DISTRIBUTION CODE MODIFICATION PROPOSAL FORM

Modification Proposal submitted By:	DATE OF SUBMISSION OF PROPOSAL:	Modification Proposal Number: <i>(to be assigned by Review Panel Secretary)</i>
Tony Hearne	9th April 2013	#23
CONTACT DETAILS FOR MODIFICATION PROPOSAL ORIGINATOR: (IF NOT DISTRIBUTION CODE REVIEW PANEL)		
NAME:		TELEPHONE NUMBER:
Tony Hearne		01 7026276
E-MAIL ADDRESS:	tony.hearne@esb.ie	
MODIFICATION PROPOSAL TITLE:	DS3 Reactive Power and voltage control	
DISTRIBUTION CODE SECTION(S) AFFECTED BY PROPOSAL		
<ol style="list-style-type: none"> 1. Table 5 2. DCC11.4 3. DCC11..5 		
MODIFICATION PROPOSAL DESCRIPTION <i>(Clearly state the desired amendment and all text changes. Attach further information if necessary)</i>		
<ol style="list-style-type: none"> 1. Update Table 5: Change from "Voltage Regulation" to Voltage Control". Update references to DCC11.4 AND DCC11.5.2.6, as depicted in Appendix 1 2. Replace the current content of DCC11.4 with the material shown in Appendix 2 3. Create new Section DCC11.5.2.6 with the material shown in Appendix 3 4. Insert new definitions per Appendix 4

MODIFICATION PROPOSAL JUSTIFICATION <i>(Clearly state the reason for the modificatio

Figure 12a

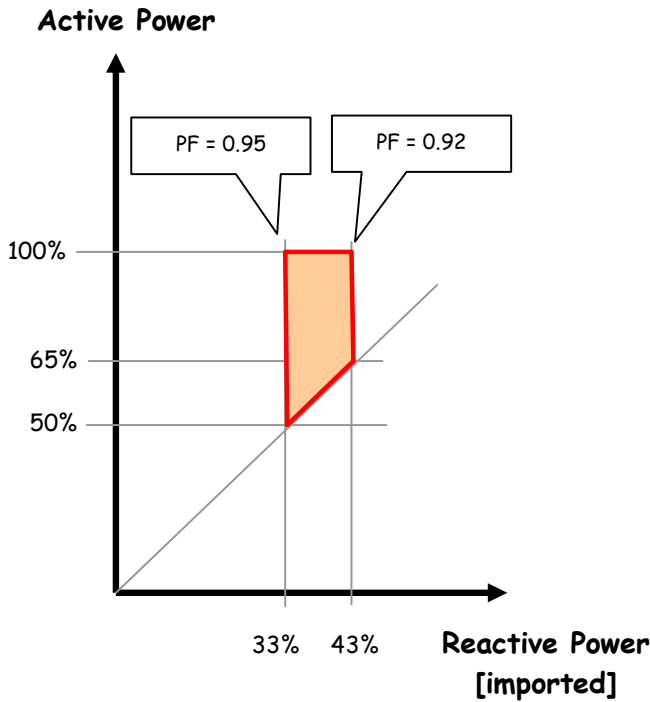
Wind Farm Power Stations, with connection types B with a Registered Capacity of <5MW and connection types C, D or E, shall keep power factor between 0.92 and 0.95, as measured at the connection point, such that VARs are absorbed by the Wind Farm Power Stations from the Distribution System. This power factor range is illustrated in Figure 12a.

Figure 13 - Reactive Power Capability of Wind Farm Power Station

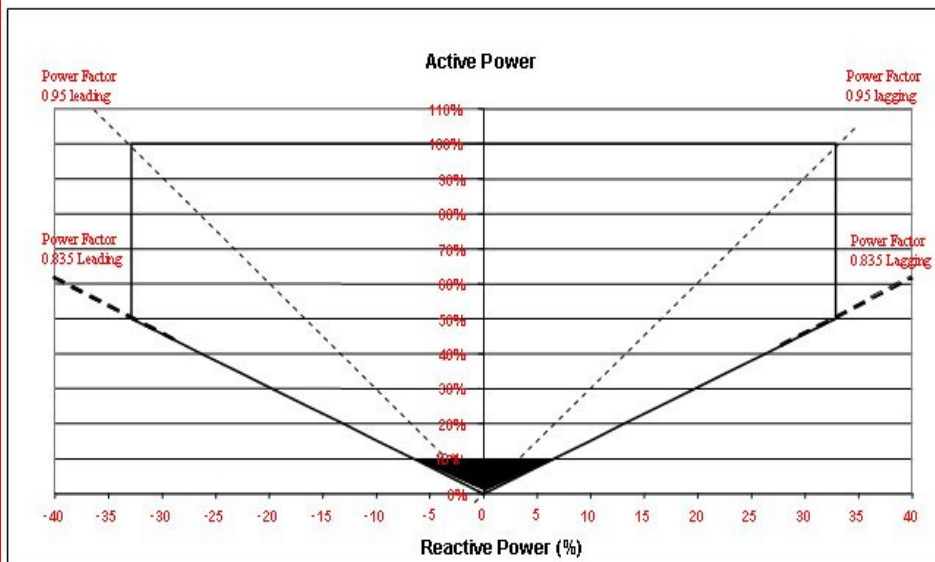
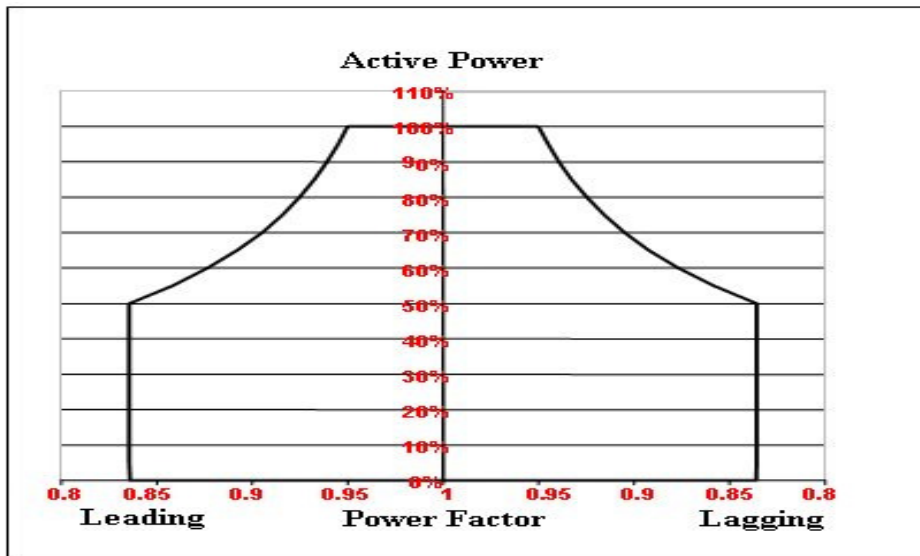
DCC11.4.5.1 Wind Farm Power Stations, Type A connected, shall be capable of operating at any point within the Power Factor ranges illustrated below in Figure 13 as measured at the lower voltage side of the 110kV step-up Transformer (point Y in Figure 12), for any Voltage at the Connection Point within the range specified above.

DCC11.4.5.2 Wind Farm Power Stations, Type B with Registered Capacity $\geq 5\text{MW}$, shall be capable of operating at any point within the Power Factor ranges illustrated in Figure 13. The capability must be implemented at the Connection Point

DSO Type A Controllable WFPSs and DSO Type B Controllable WFPSs with Registered Capacity $\geq 5\text{MW}$, operating in **Power Factor** control mode, Voltage Control Mode or Constant Reactive Power mode shall be at least capable of operating at any point within the P-Q capability ranges illustrated in *Figure 13*, as measured at the **Connection Point** and shall be capable of providing this capability over the full range of voltages specified in Table 5A.

Figure 13

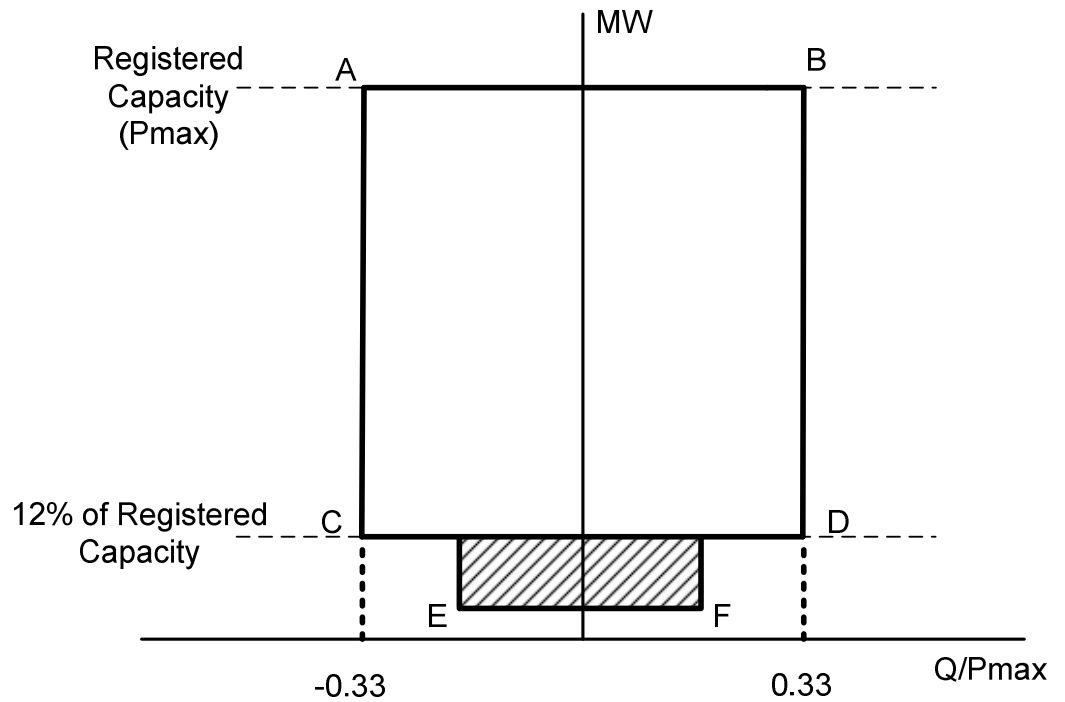
Point A represents the minimum Mvar absorption capability of the **Controllable WFPS** at 100% **Registered Capacity** and is equivalent to 0.95 power factor with the **WFPS** importing VARs;

Point B represents the minimum Mvar production capability of the **Controllable WFPS** at 100% **Registered Capacity** and is equivalent to 0.95 power factor with the **WFPS** exporting VARs;

Point C represents the minimum Mvar absorption capability of the **Controllable WFPS** at 12% **Registered Capacity** and is equivalent to the same **Mvar** as Point A;

Point D represents the minimum Mvar production capability of the **Controllable WFPS** at 12% **Registered Capacity** and is equivalent to the same **Mvar** as Point B;

Point E represents the minimum Mvar absorption capability of the **Controllable WFPS** at the cut-in speed of the individual **WTGs**;

Point F represents the minimum Mvar production capability of the **Controllable WFPS** at the cut-in speed of the individual **WTGs**;

It is accepted that the values of Points E and F may vary depending on the number of **WTGs** generating electricity in a low-wind scenario;

Figure 13 represents the minimum expected reactive power capabilities of the **Controllable WFPS**. The **Controllable WFPS** is obliged to tell ESB Networks if it can exceed these capabilities, and submit the actual P-Q capability diagram based upon the installed plant and **Collector Network** characteristics to the **DSO** during **Commissioning**.
